From: "Norm Wohlabaugn" <wohlabaugn@op-tech.us>
To: "Linda Ross" <lcross@gw.dec.state.ny.us>
CC: "Todd Bown" <bownt@op-tech.us>, "Linda Grimmer" <grimmerl@op-tech.us>
Date: 11/11/2009 10:31 AM
Subject: Revised Scope of Work - Standard Portable
Attachments: Revised Boring Location Map.pdf

OP-TECH	
Environmental Services, Inc.	
Figure 1: Site Plan Former Standard Portable Mayville, New York	
Scale: See Bar Scale	Date:
Project #: FD900431	9/15/2009

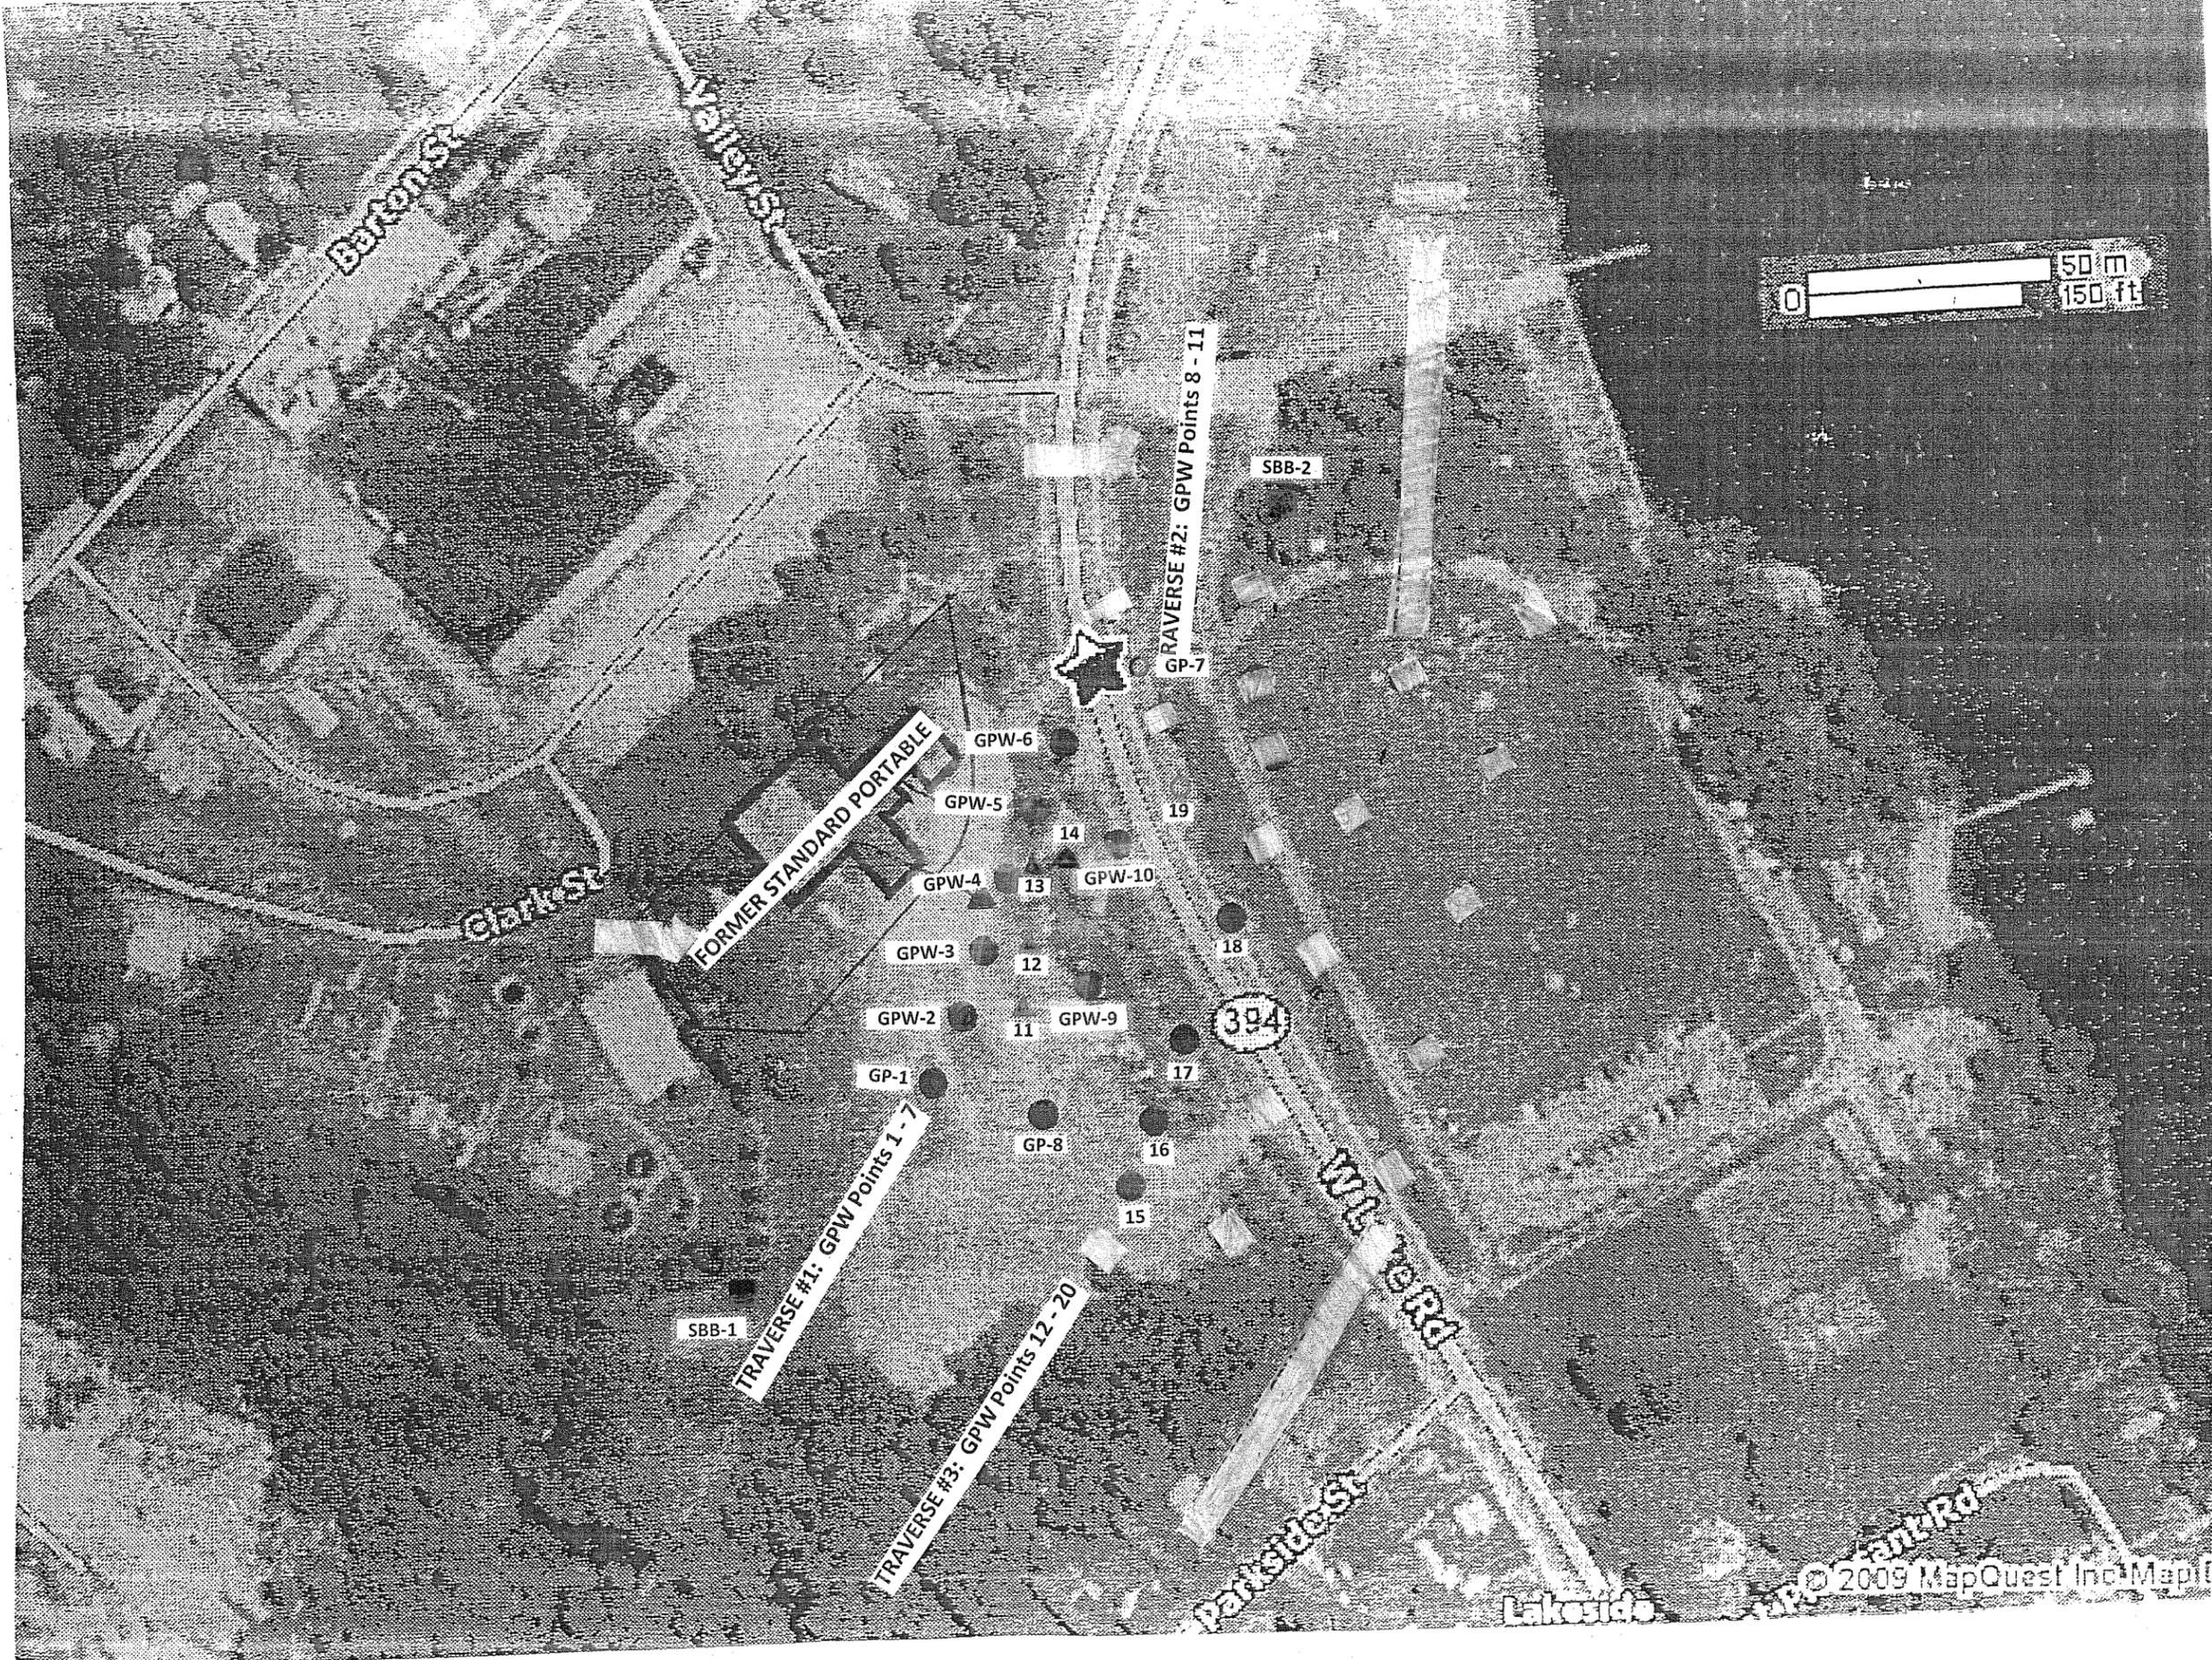
Good morning. I am forwarding a revised map that shows the recommended drilling locations for the rest of the project. Based on the field information to date, we don't feel it is necessary to drill any of the borings in Traverse 4 and 5, as originally proposed, and plan to reduce the scope of work from 32 borings (including the two exploratory borings) to 21 borings.

As discussed yesterday,, we will drill 4 new borings between the Traverse 1 and Traverse 2 borings. These new locations are numbered 11, 12, 13, and 14 on the attached drawing. Borings 11, 12, and 14 are on the east side of the force main and sewer that runs through the site, while 13 is to the west of them. These borings should help us understand where the edge of contamination is located, and whether or not the bedding around the force main and sewer is acting as a collection point for contamination.

Wells were placed in GPW-2, GPW-3, GPW-4, GPW-5 and GPW-6 based on PID readings from the soil samples collected from the respective borings. We had no PID readings or hits in GP-1, GP-7, GP-8, GPW-9 or GPW-10, but placed wells in GPW-9 and GPW-10 to make sure we had good groundwater monitoring points downgradient of the suspected edge of the plume.

We also recommend placement of wells in 11, 12, 13, and 14 as appropriate, as well as at least one additional well in either 15, 16 or 17, and a well in 18 and 19 to assure that we have good monitoring points downgradient.
